**RE: Lime Slurry Feed System For The Lyall Street Water Treatment Plant
City of Bennettsville, South Carolina
Project No. 60753190**

ADDENDUM NO. 2 – MARCH 20, 2026

SHEET NUMBER
C01.20

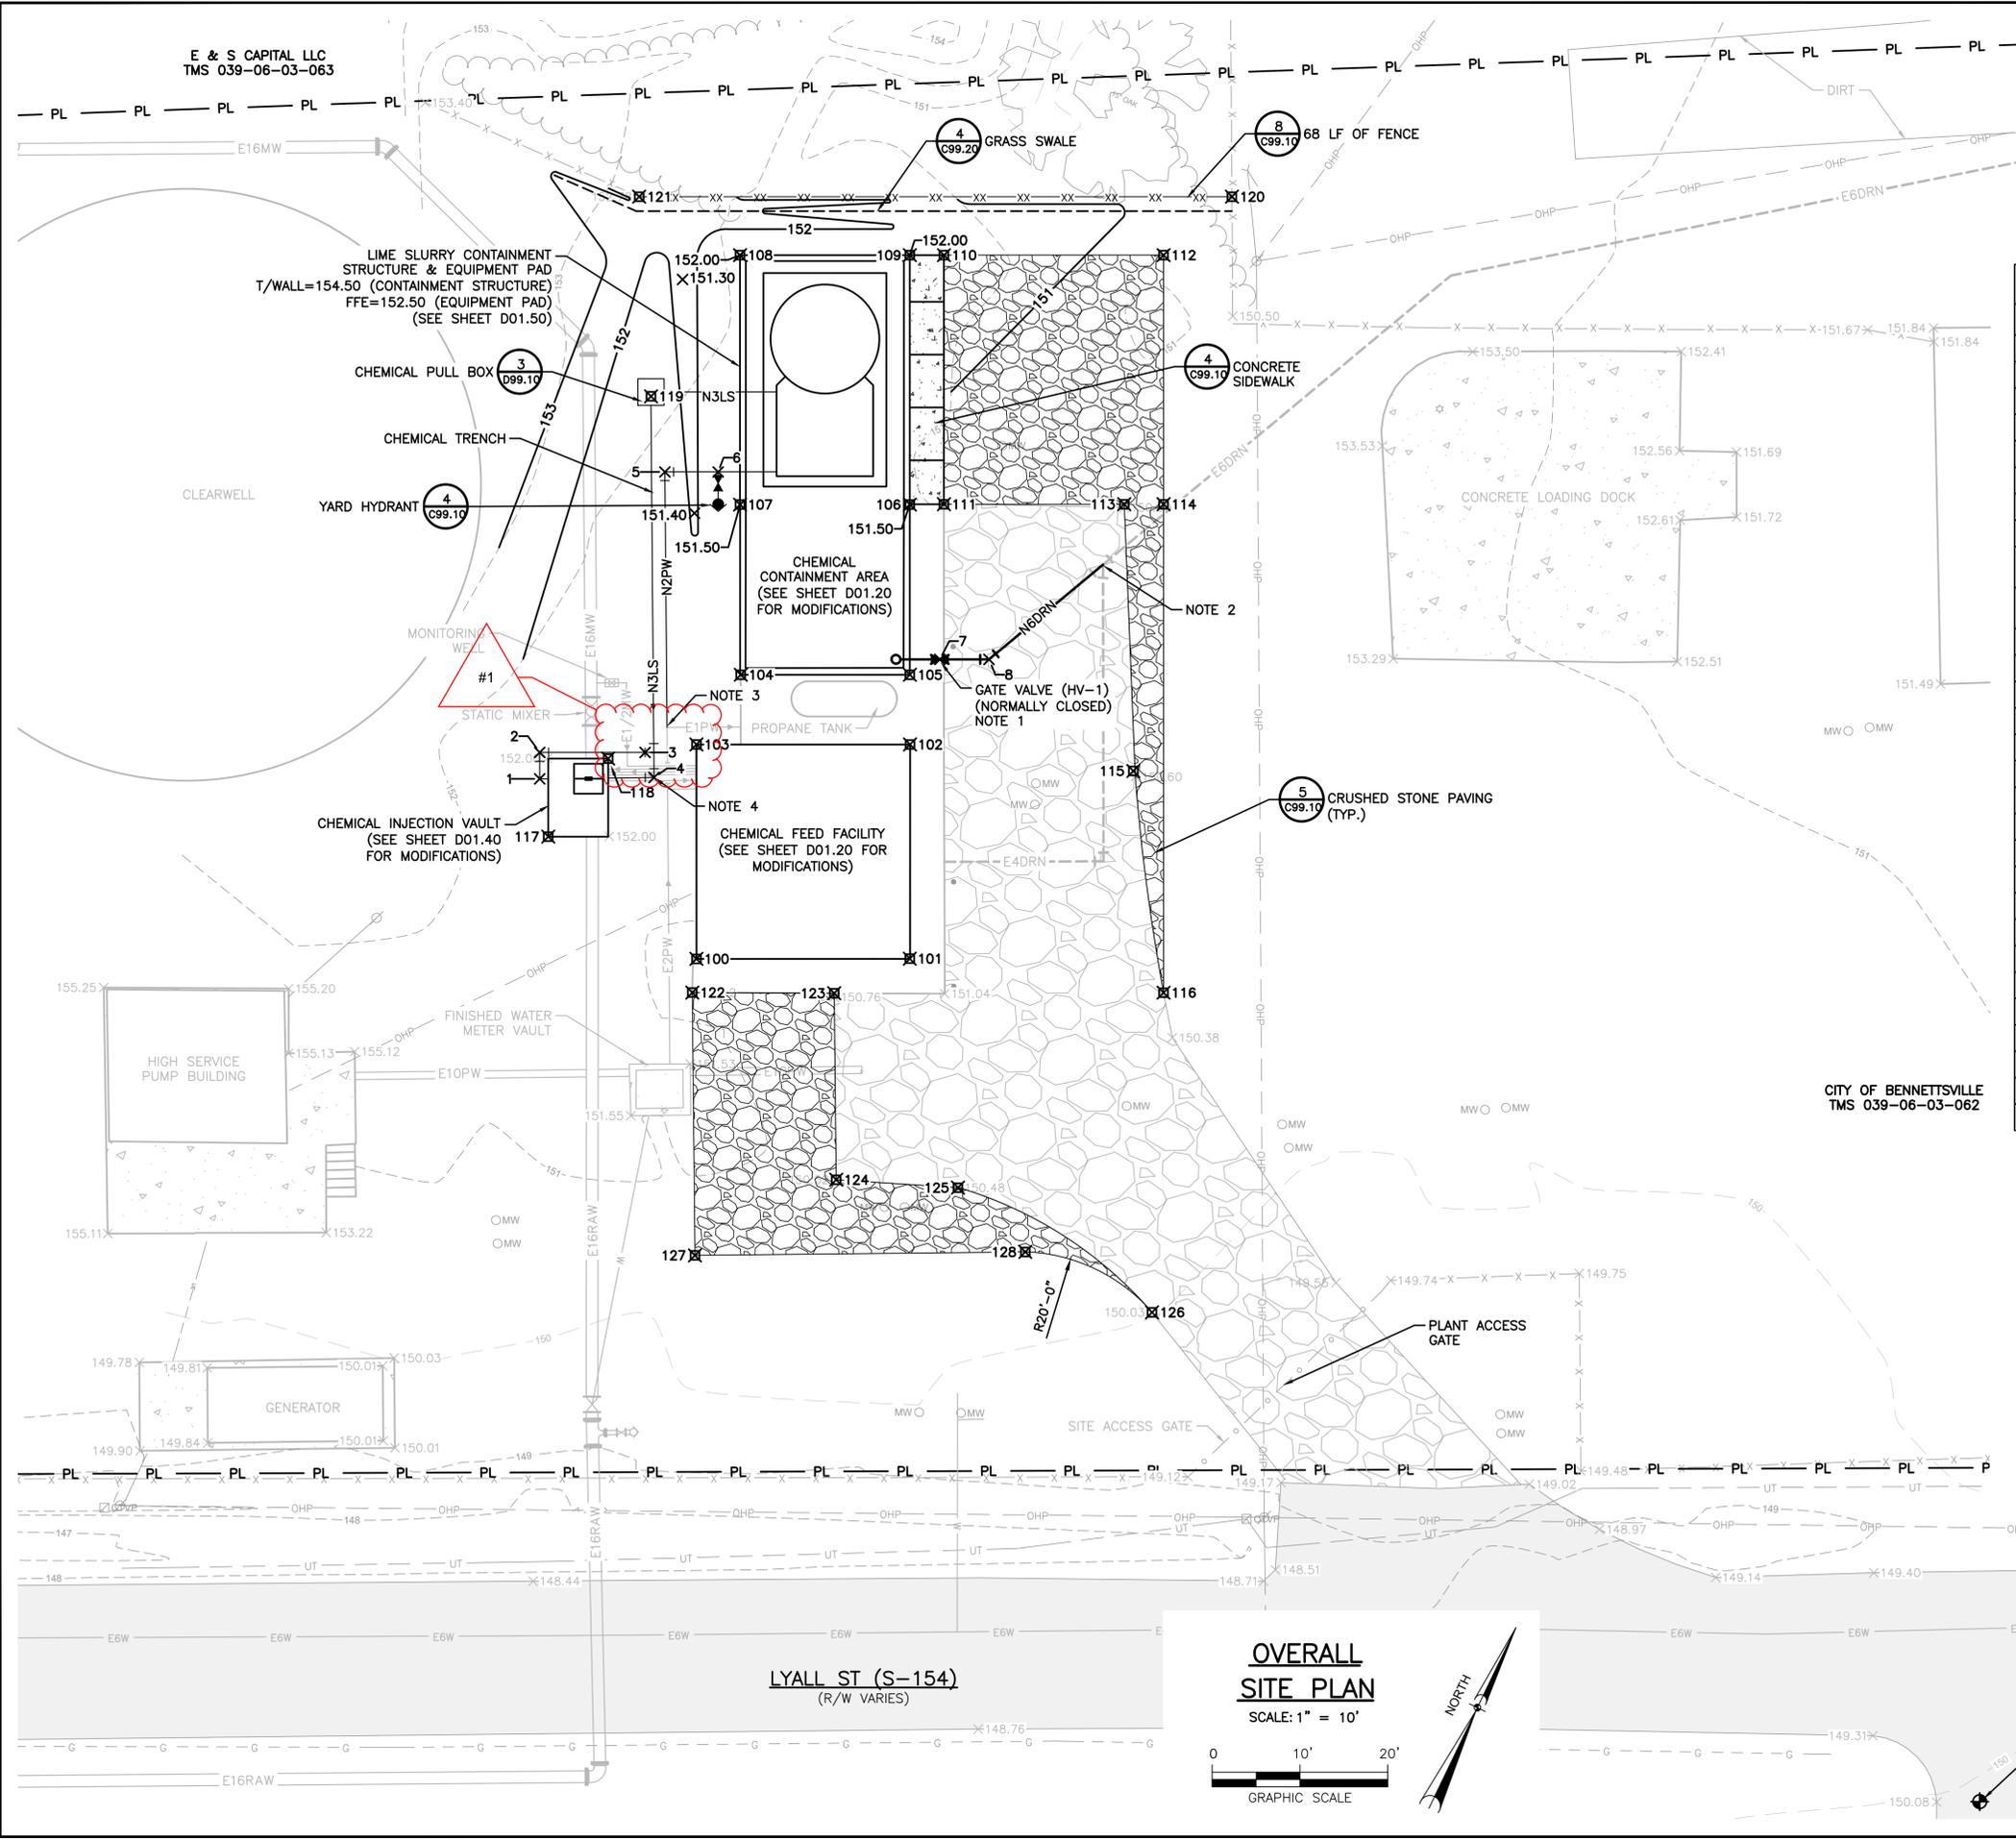
I've got some questions about the Lime Slurry Feed System for the Lyall St Water Treatment Plant. Sheet C01.20 shows (2) separate N3LS lines going from the chemical pull box to the chemical injection vault.

1.) See revised drawings: C01.20, D01.20 and D01.40

SHEET NUMBER
 D01.20

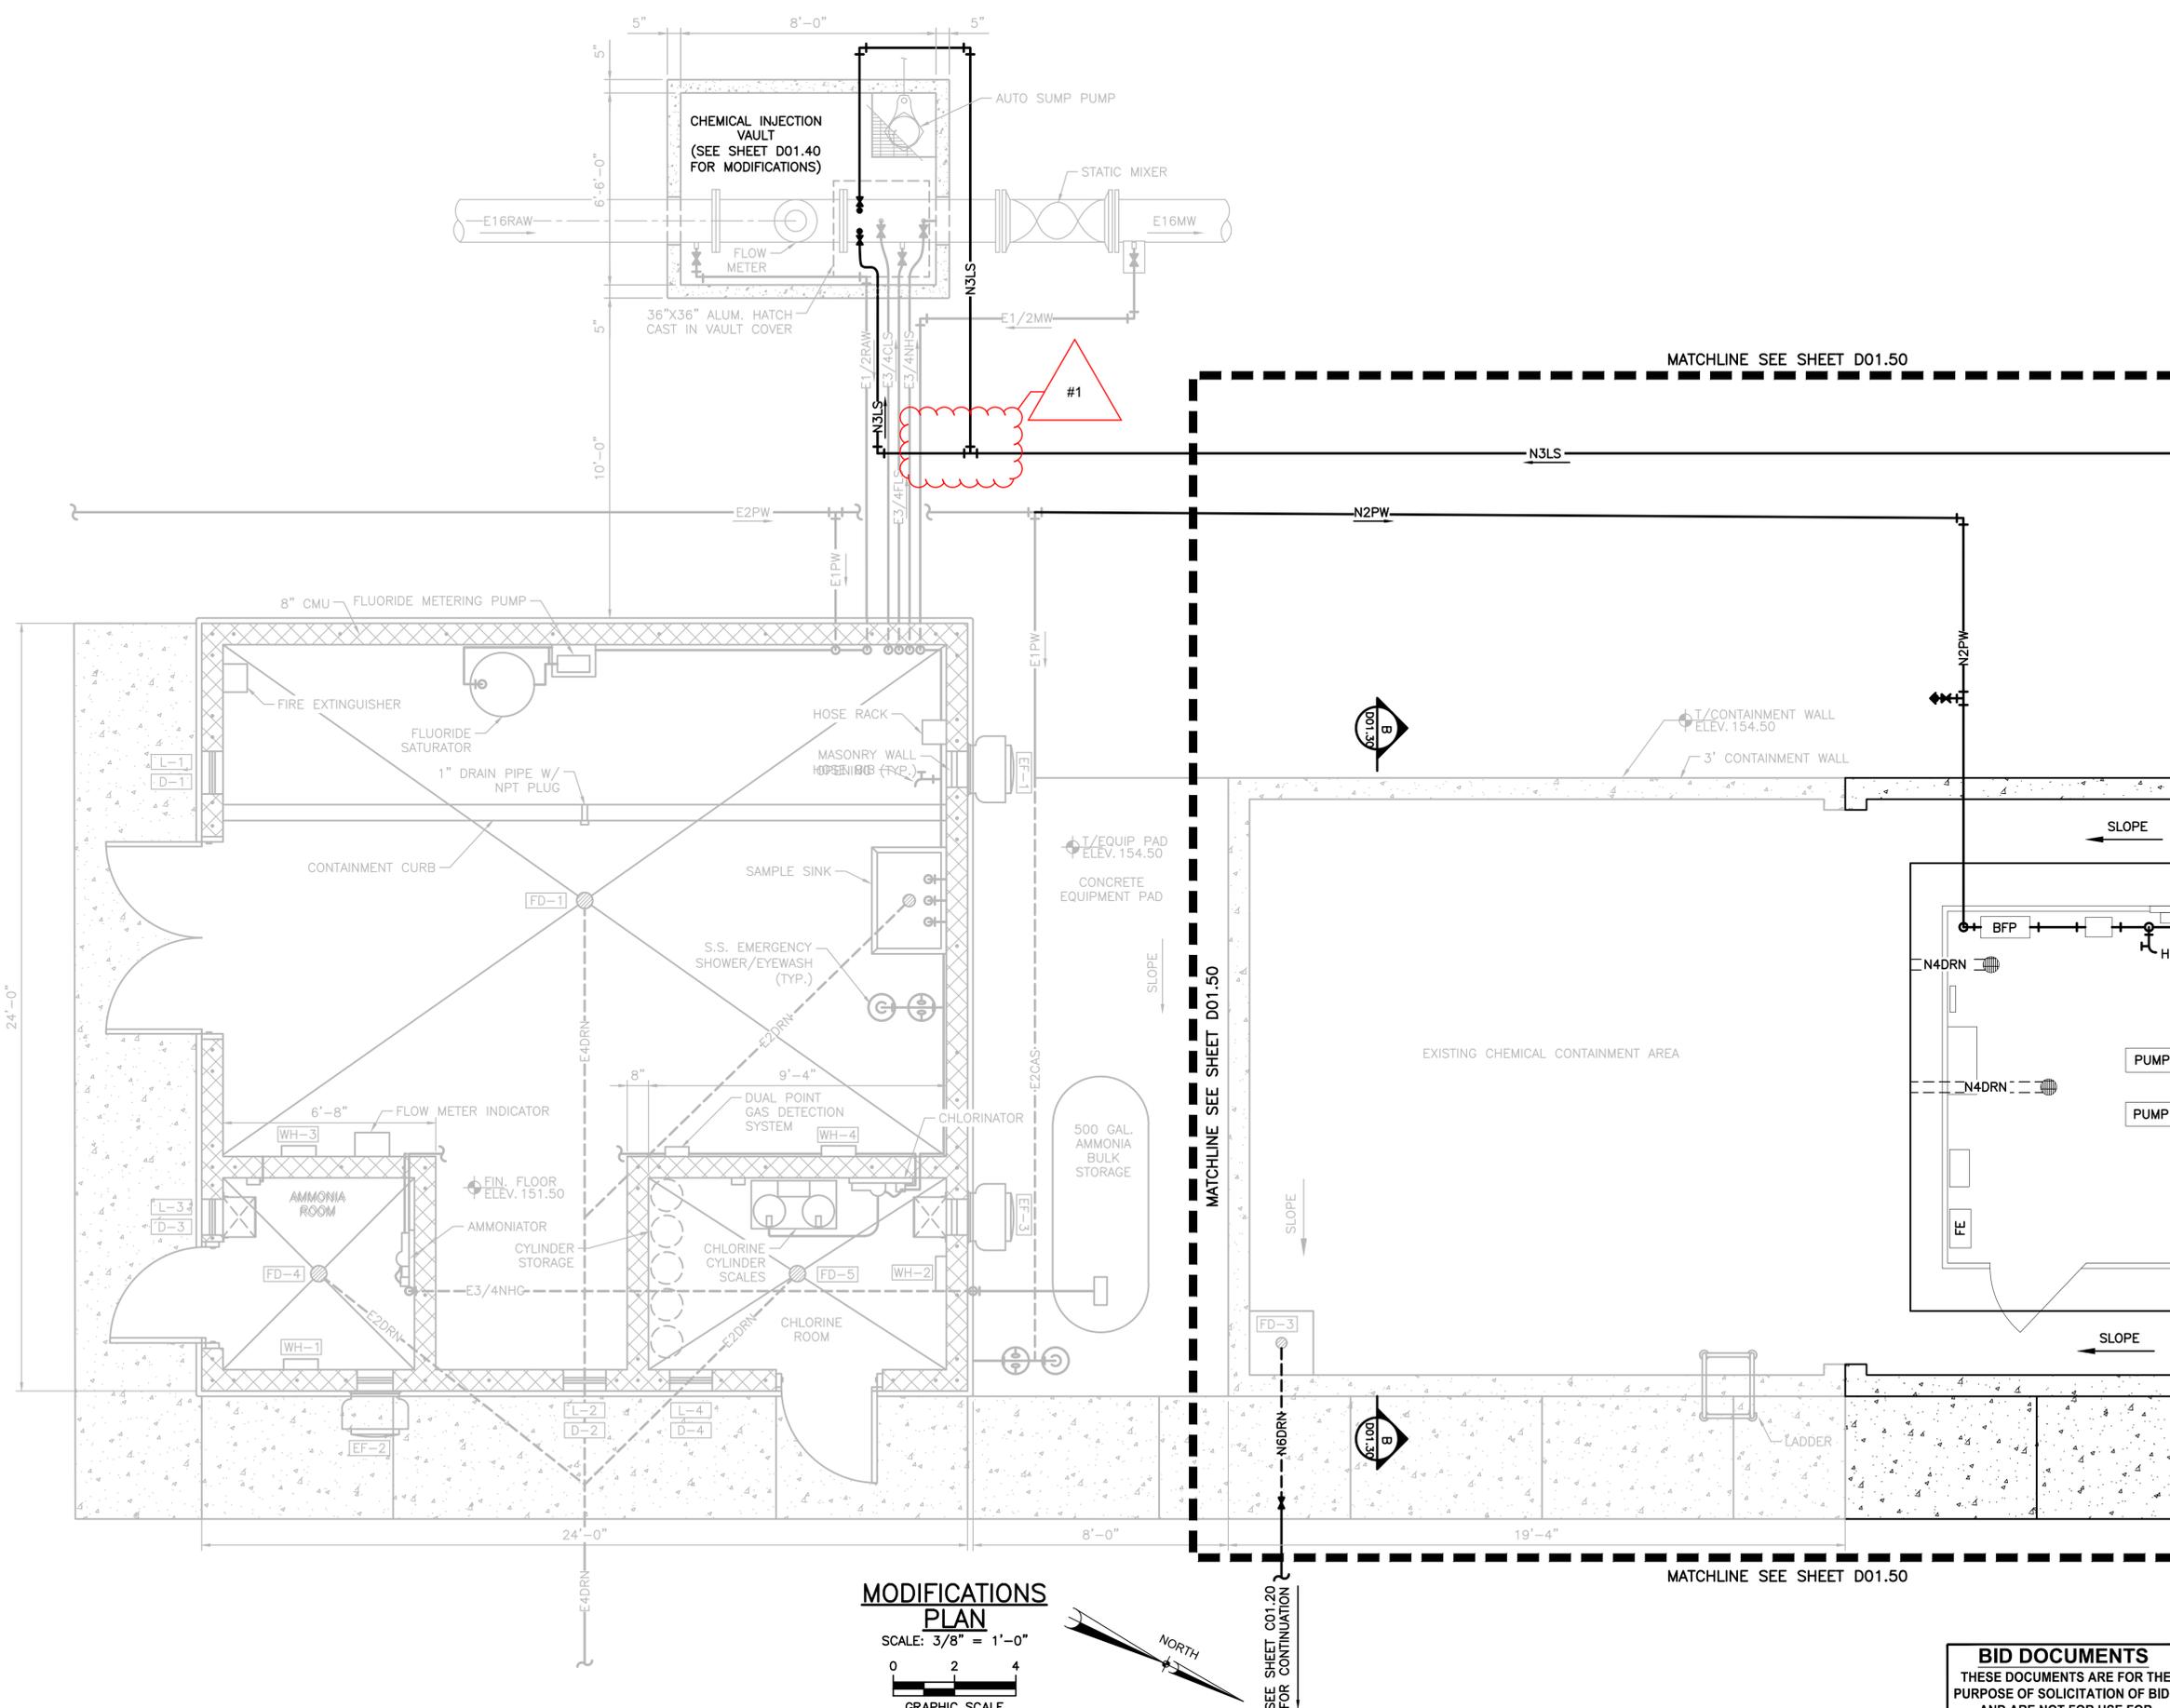
Sheet D01.20 shows (1) N3LS going from the chemical pull box to the chemical injection vault and framing with a tee to wrap around the chemical injection vault.

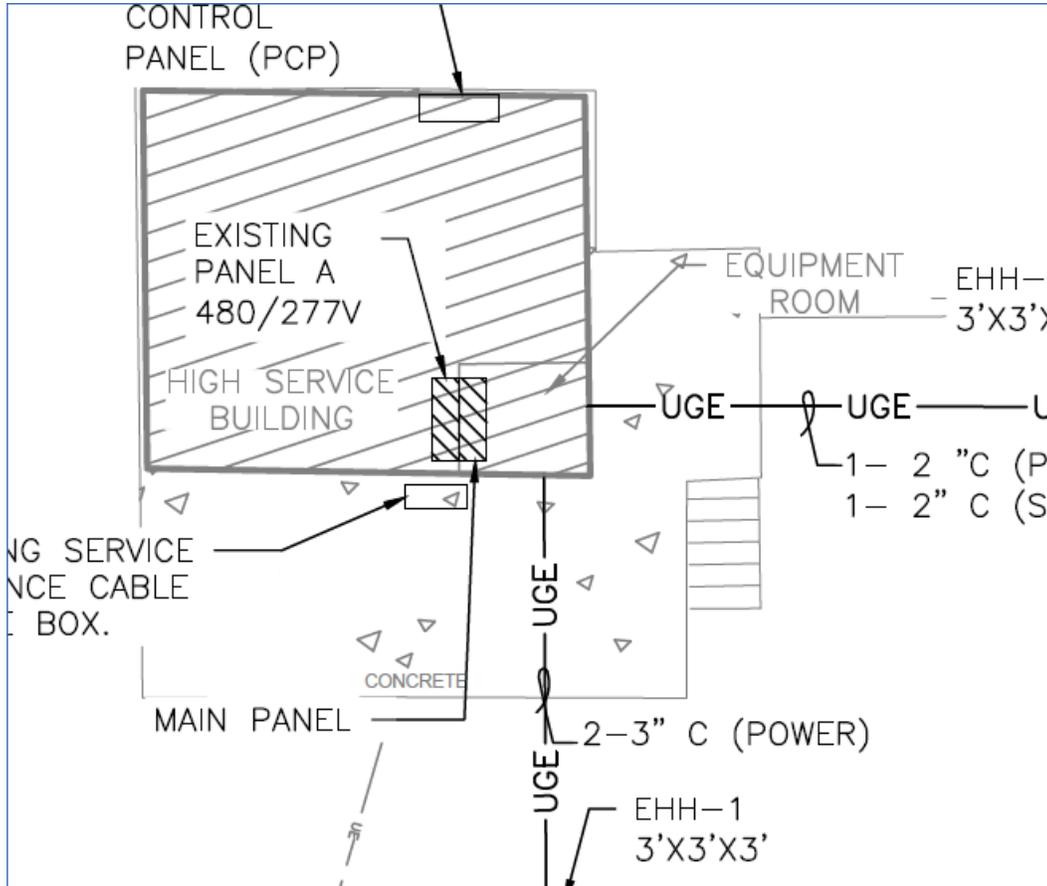
What is the plan to get the new underground electrical conduit into the room with the "New 500A Service Rated Panel" shown on E01.00 and E01.30? Where the underground conduit is shown is an elevated building. Can we switch to rigid conduit for the conduit in and out of that building like some of it appears to currently be? Or do we need to sawcut the existing concrete? See attached photo of the existing building.

The new conduit shall be routed above grade and installed against the existing concrete wall/ramp as shown in the RFI photo. At the point where the conduit transitions above ground, it shall change to PVC-coated rigid steel conduit. The conduit shall be horizontally supported along the concrete ramp and vertically supported against the wall in accordance with the support requirements of NEC 344.30 and spec section 16400-3.4.
